Addendum No. 03

September 11, 2025

SUCF Project No. 221038-00

Renovate Pioneer Center

WATER SERVICE ALIGNMENT STATIONING

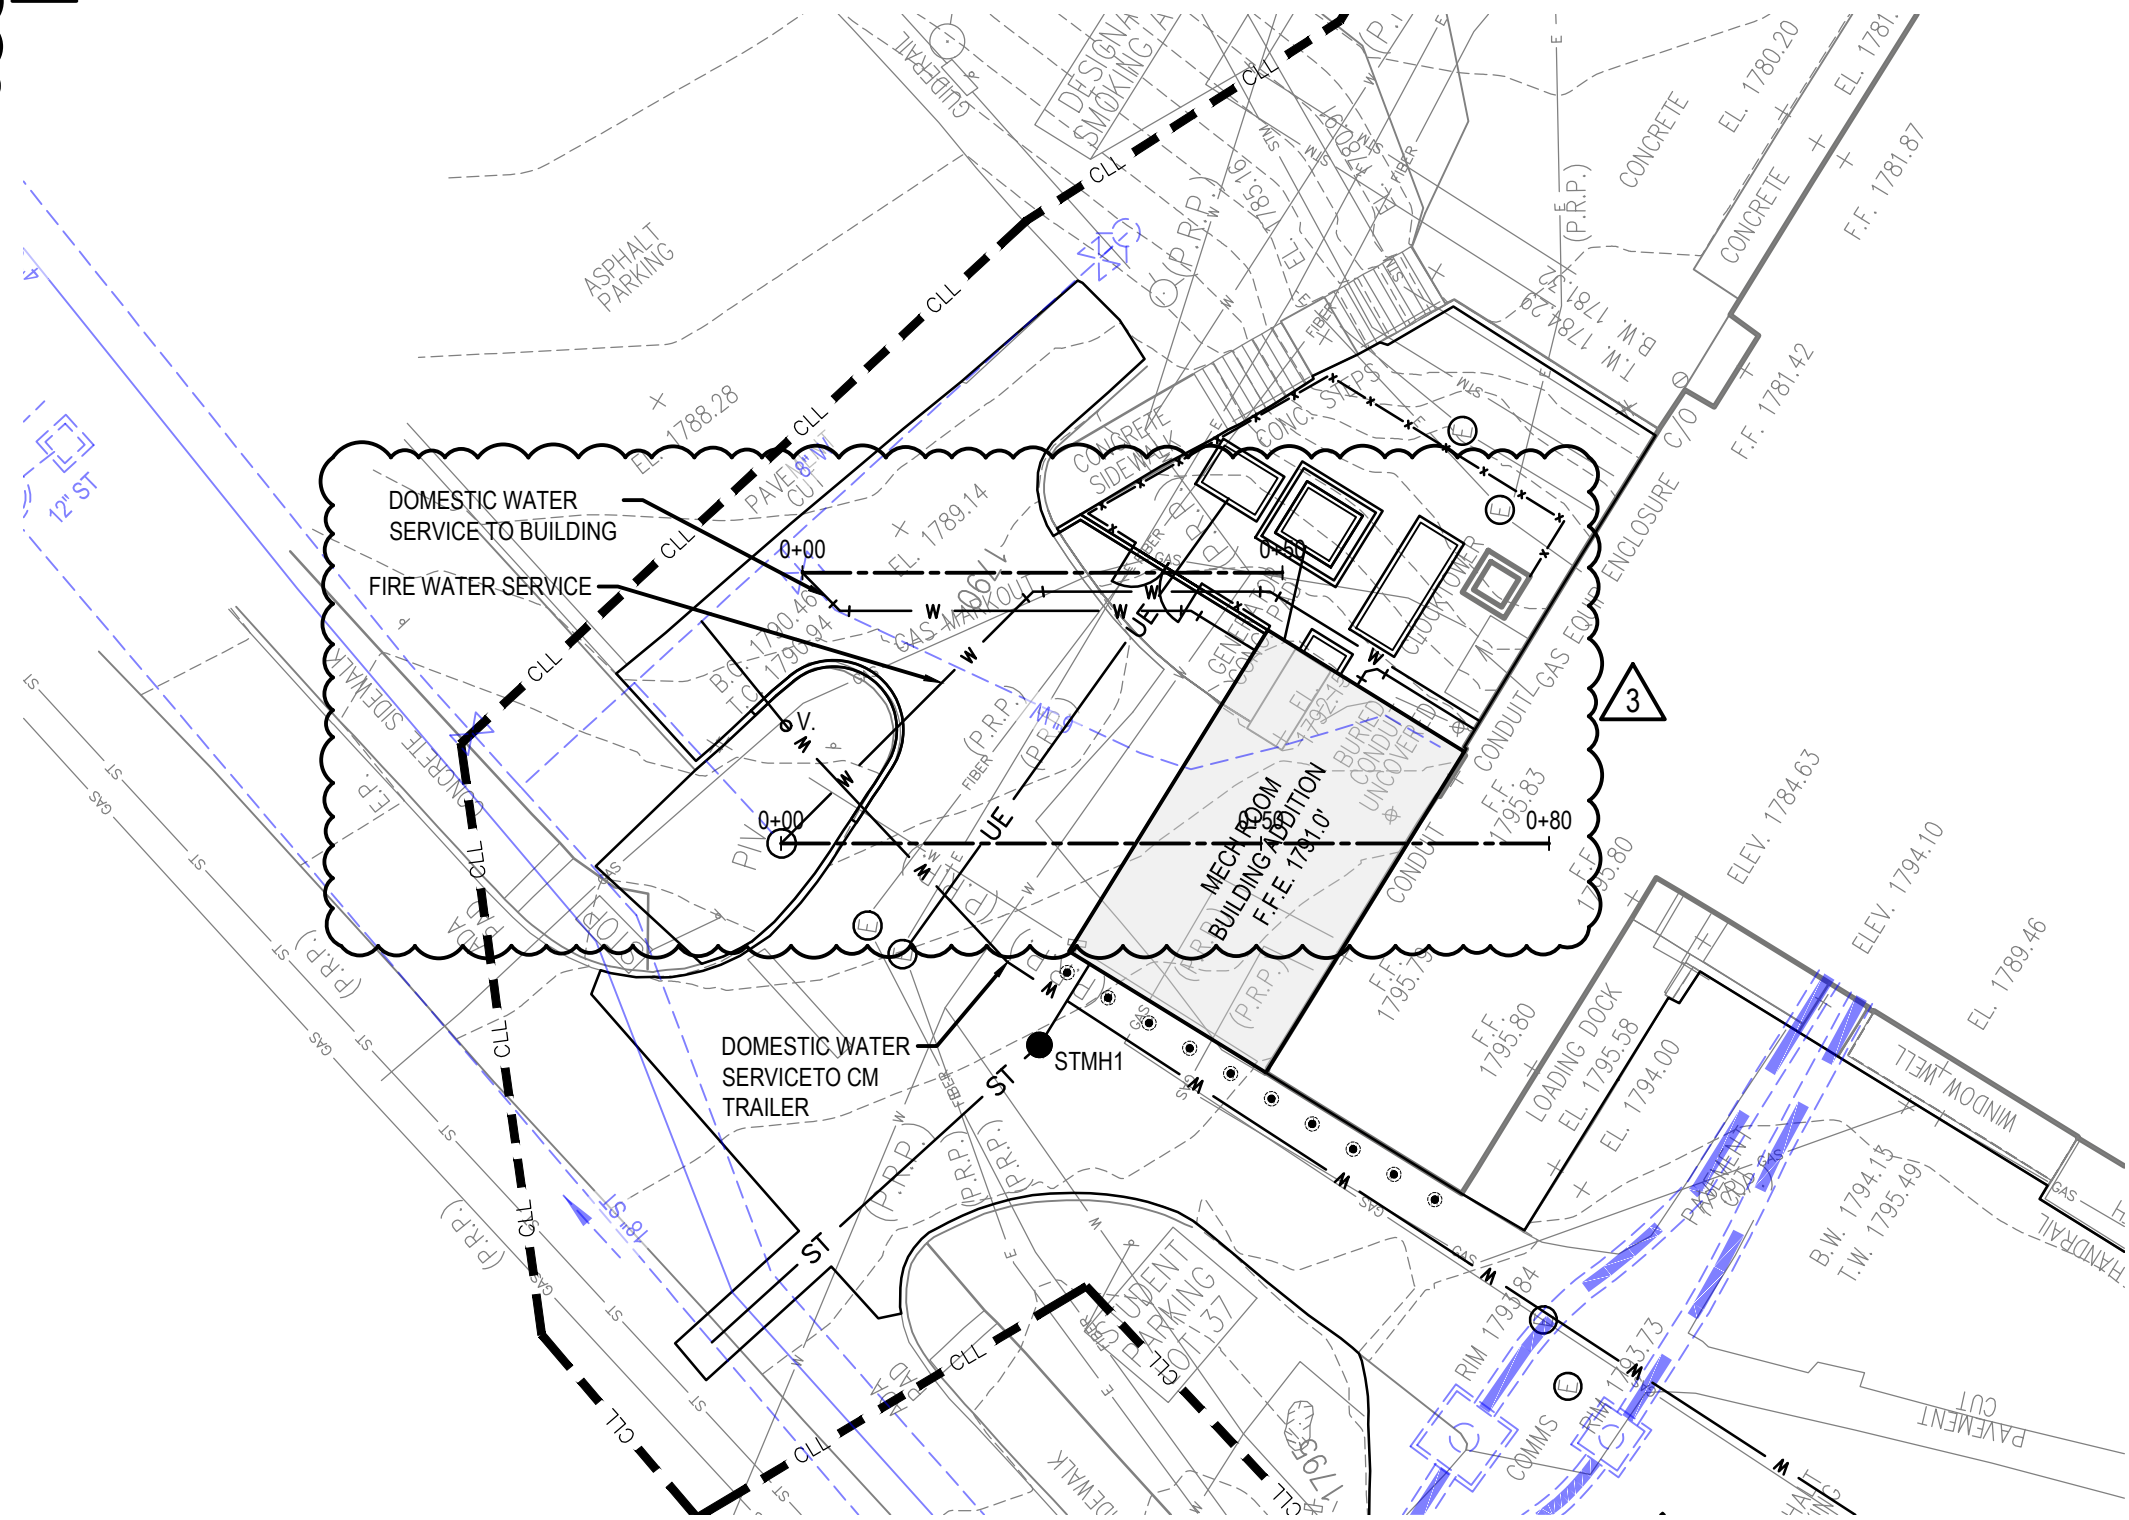
Replace: Alignment Stationing plan 1/C-301 with Water Service Alignment Stationing plan as indicated on CSK-011.

6-INCH DUCTILE IRON DOMESTIC WATER SERVICE PROFILE

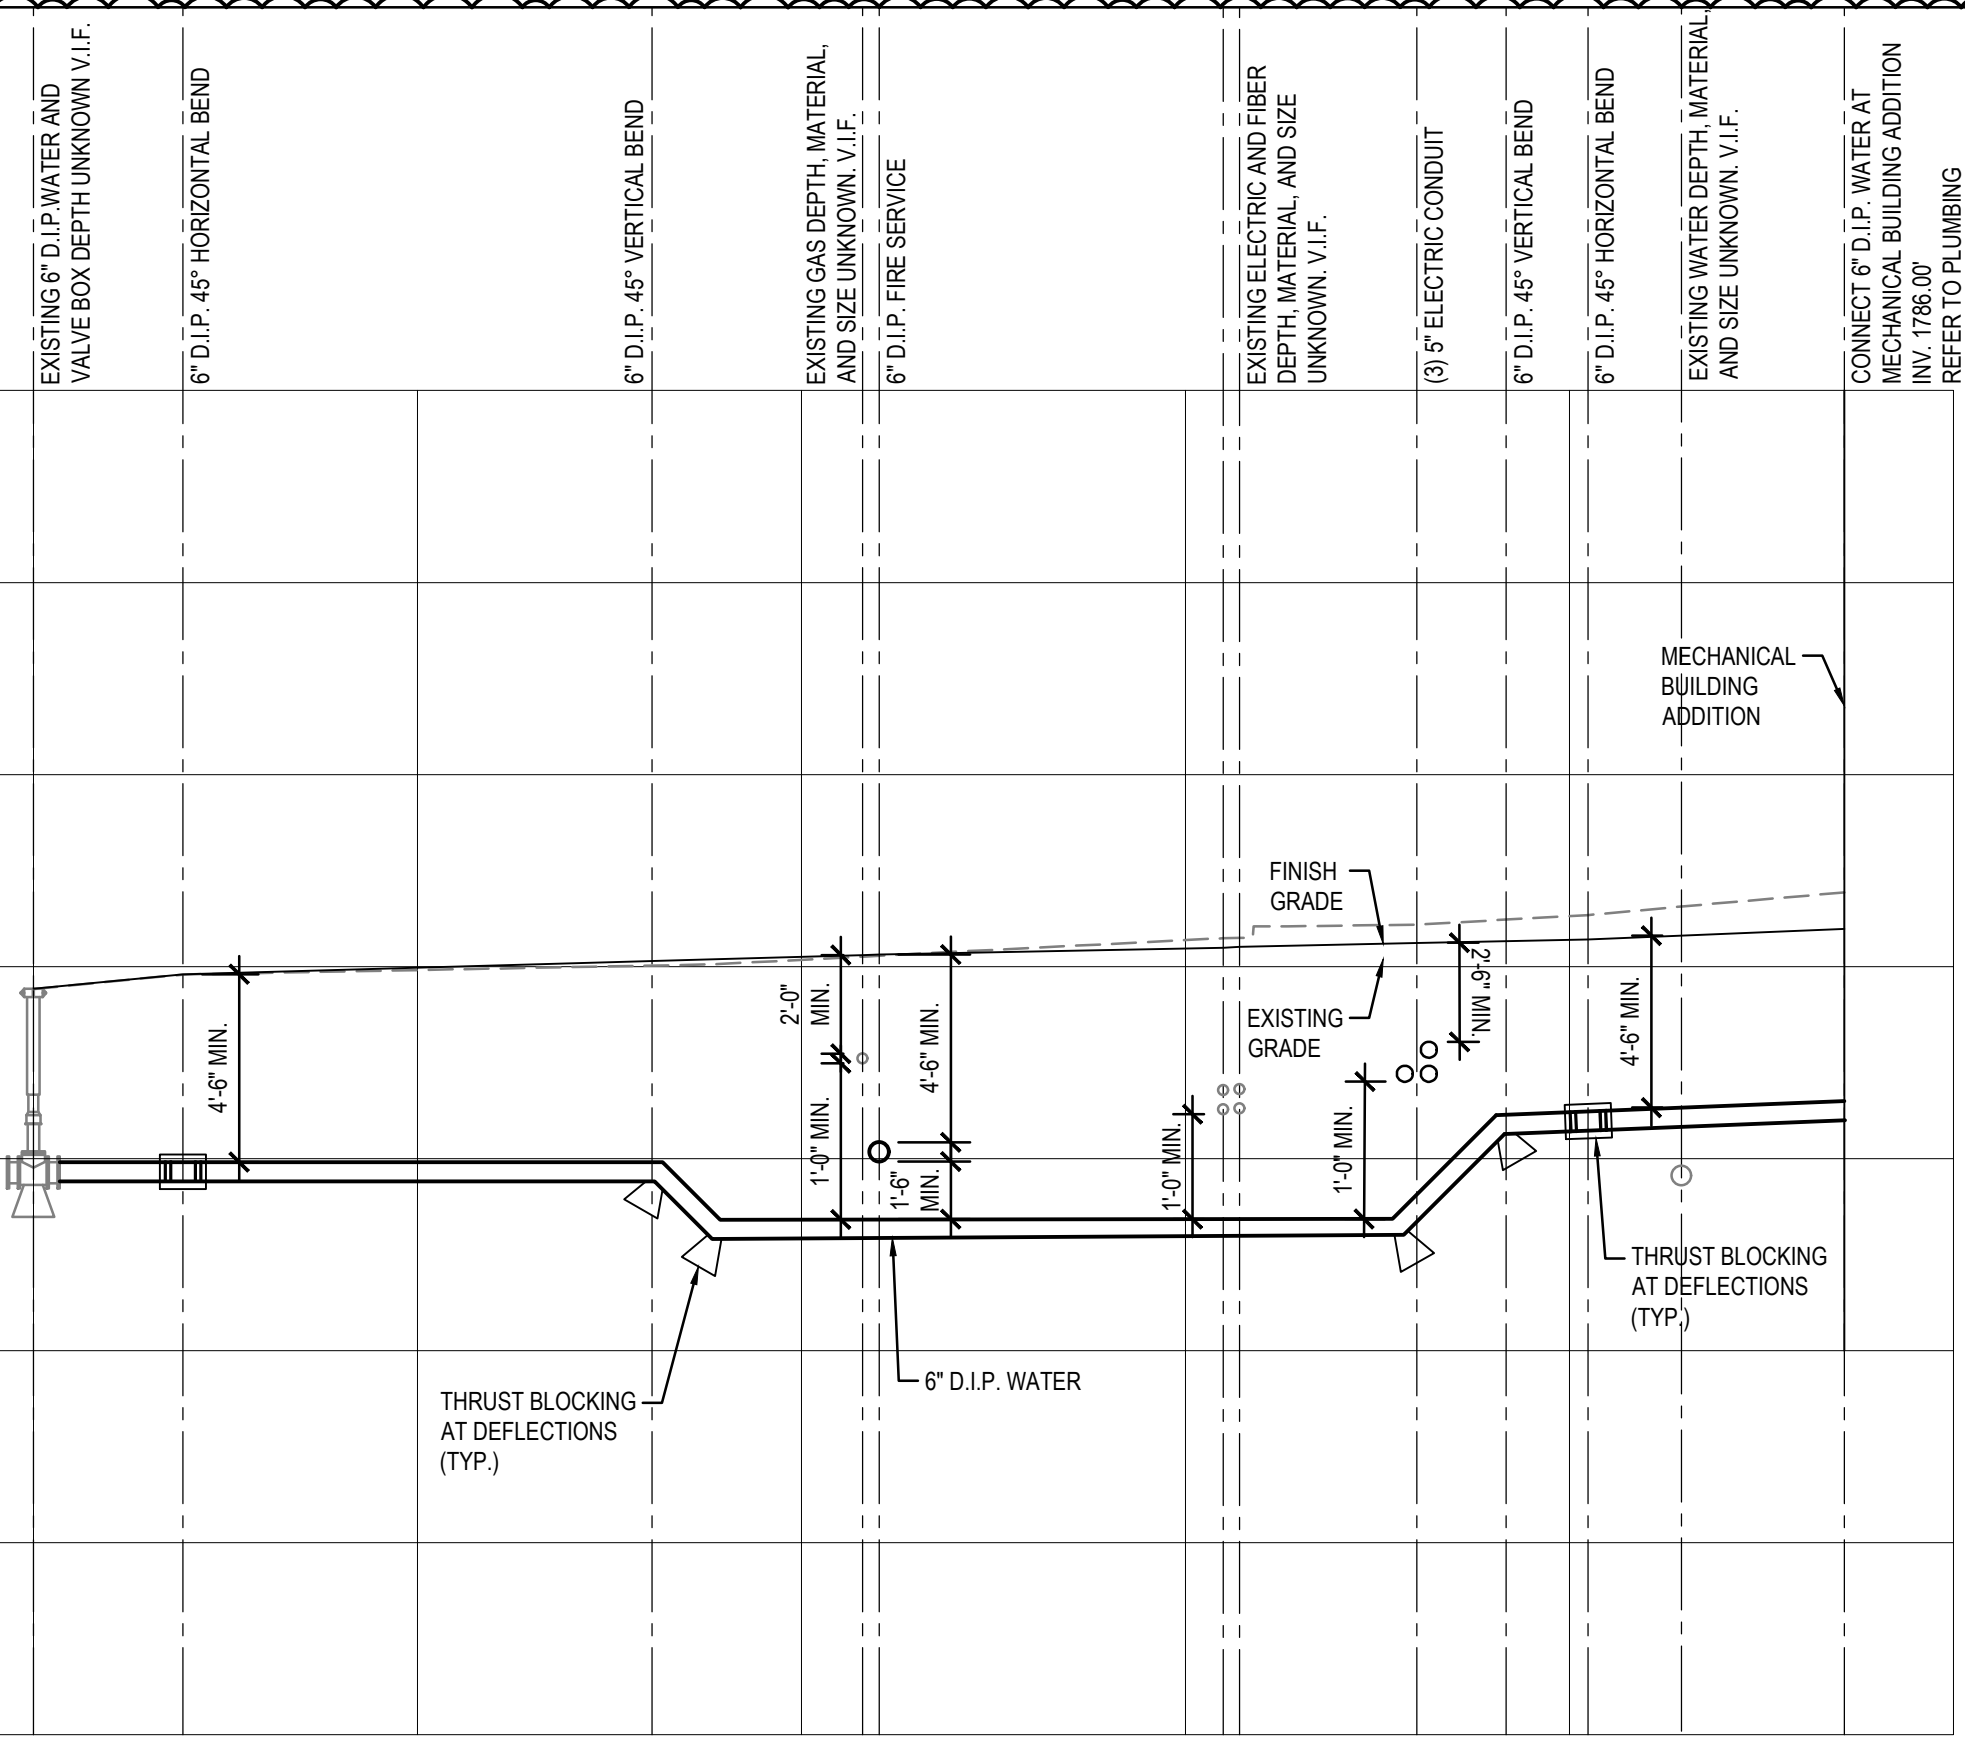
Revise: 6-Inch Ductile Iron Domestic Water Service Profile 2/C-301 as indicated on drawing CSK-012.

6-INCH DUCTILE IRON FIRE WATER SERVICE PROFILE

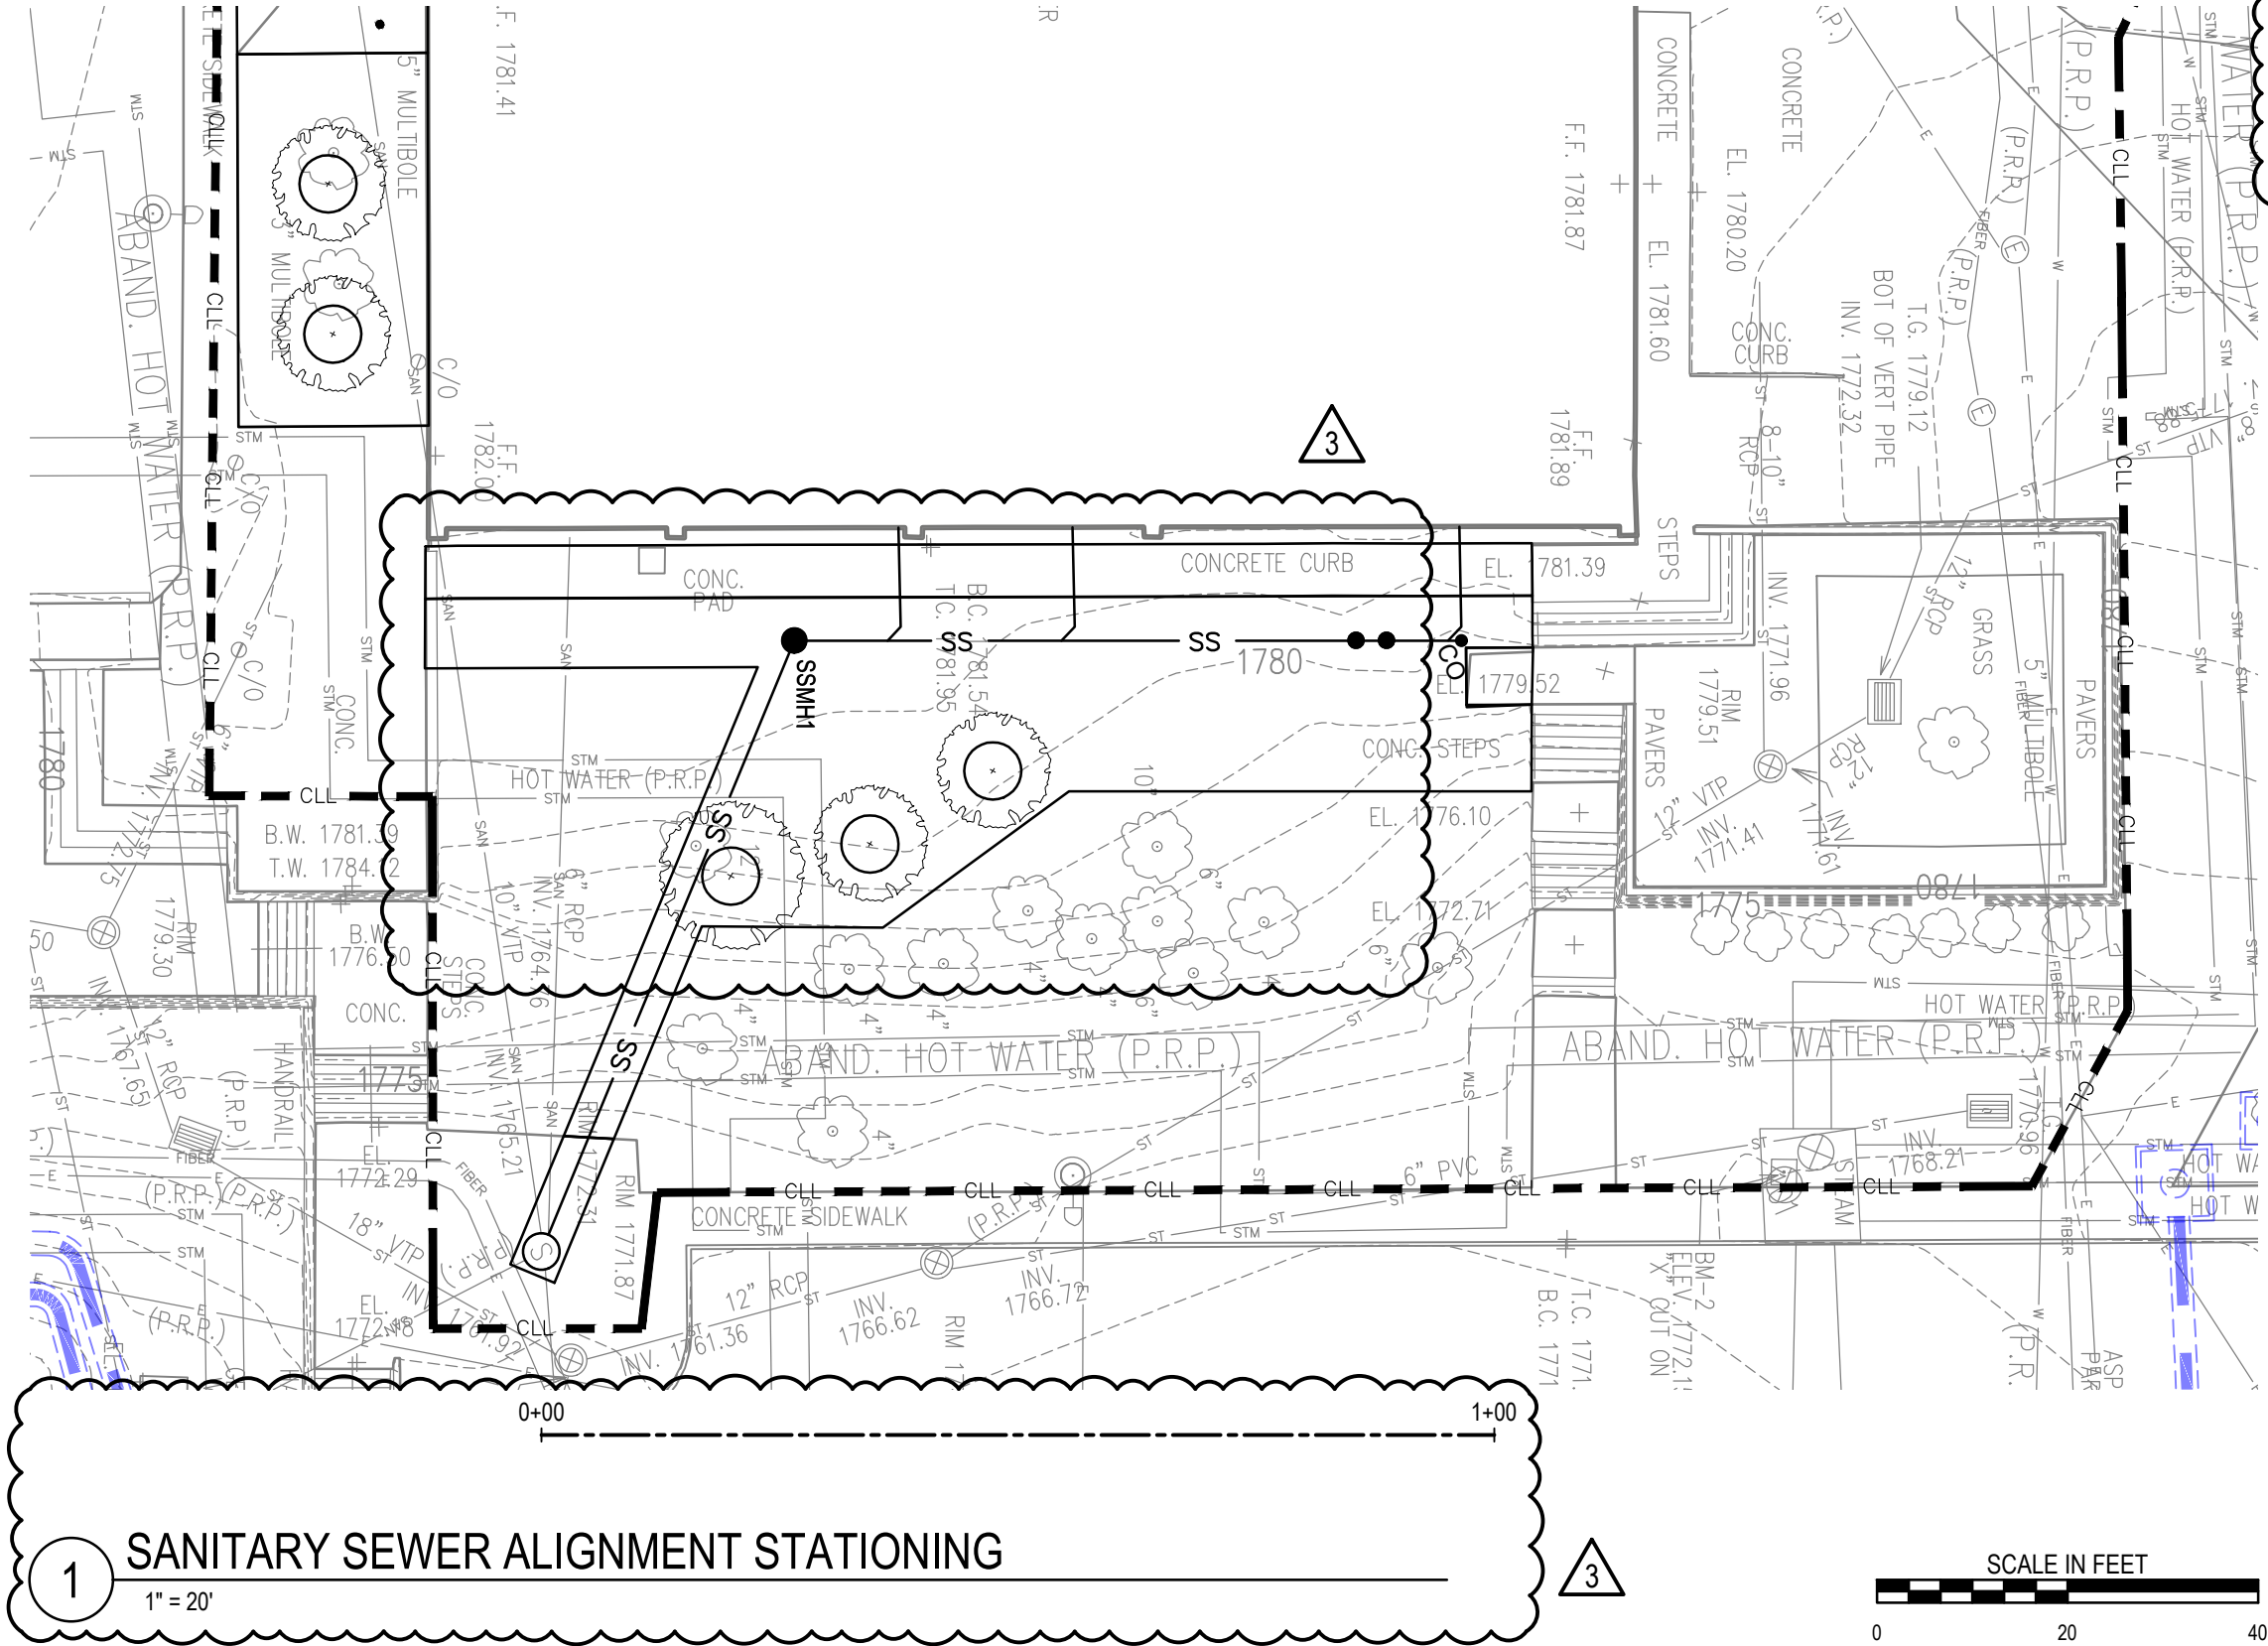
Revise: 6-Inch Ductile Iron Fire Water Service Profile 3/C-301 as indicated on drawings CSK-013 and CSK-014.
